# CITY OF PORTLAND, MAINE

Project Name: **Bangor Savings Bank Bank/Office building with two lane drive-through**  
Project ID: #2015-080  
Address: 20 Marginal Way CBL: 113 A 025001  
Applicant: Wendy Durrah, Bangor Savings Bank  
Planner: Jean Fraser

# PLANNING BOARD REPORT PORTLAND, MAINE

Bank/Office Building with Bank Drive-through, 20 Marginal Way  
Level III Conditional Use and (Level II) Site Plan  
Bangor Savings Bank, Applicant  
Project #: 2015-080  
CBL 113 A025001

**CURRENT FINAL PROPOSAL  
(Landscape Plan in Plan P10)**

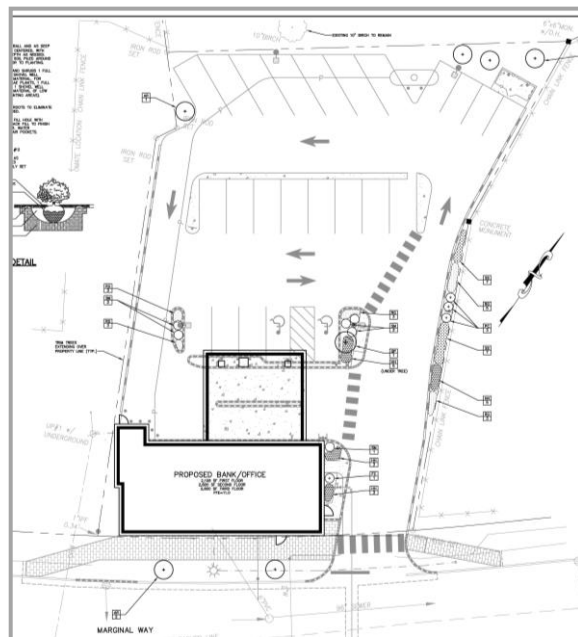
The site has limited areas for landscaping and the applicant had originally requested a waiver for parking lot landscaping (with contribution to the Tree Fund instead. Staff do not support the waiver because screening of parking is also part of the B7 Design Standards, and because of the absence of landscaping along the eastern boundary (where the view towards the proposed parking is clearest from the sidewalk and street).

Staff met with the applicant and suggested that there was scope for a number of smaller spaces for planting so that cumulatively the landscape would meet the ordinance requirements which state:

The final Landscape Plan (Plan P10) has been prepared by a Landscape Architect and includes many improvements, although the City Arborist remains of the view that more could be done (Attachment 3):

*The proposed Bangor Savings Bank landscape plan for Marginal Way is acceptable with the condition that ONE tree is planted in the rear right side traffic island and vegetation is added to the proposed rear curbing area.*

*The attached photos demonstrate that ornamental grasses can grow in restricted spaces, this is an MDOT project called Hagis Parkway / Route One in Scarborough where they successfully use beach grass in a high salt area with good results. The overall Bangor Savings Bank project has much less than average landscape percentage due to lot orientation and circulation patterns, however a simple planting of low maintenance beach grass would work, thus is a recommended condition of approval.*

Tom Errico, Traffic Engineering reviewer, has confirmed that the rear drive aisle could be narrowed from 19' to 18' to provide an extra foot in the curbed area for the suggested planting (Attachment 2).

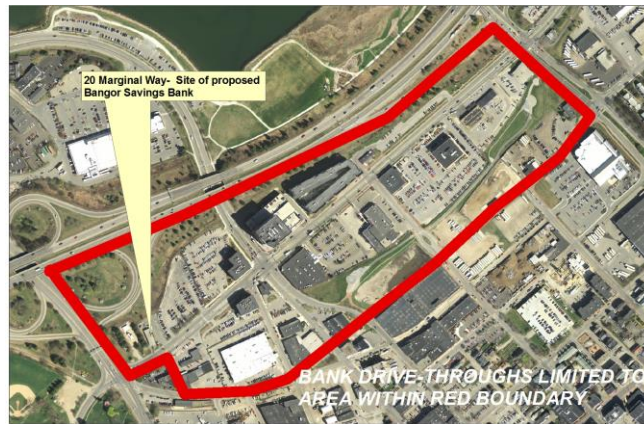
- v. *The site must have adequate stacking capacity for vehicles waiting to use these service features without impeding vehicular or pedestrian circulation or creating hazards to vehicular or pedestrian circulation on adjoining streets; and*
- vi. *Drive-up vehicle circulation shall not be located between the building and any adjacent public streets; and*

**Staff comment:** The proposed vehicle circulation takes the drive-through customers around the rearmost drive and then down the west side to enter the drive-through from the west. This provides stacking area along the west boundary of the site and ensures that it is not near Marginal Way nor across any pedestrian routes.
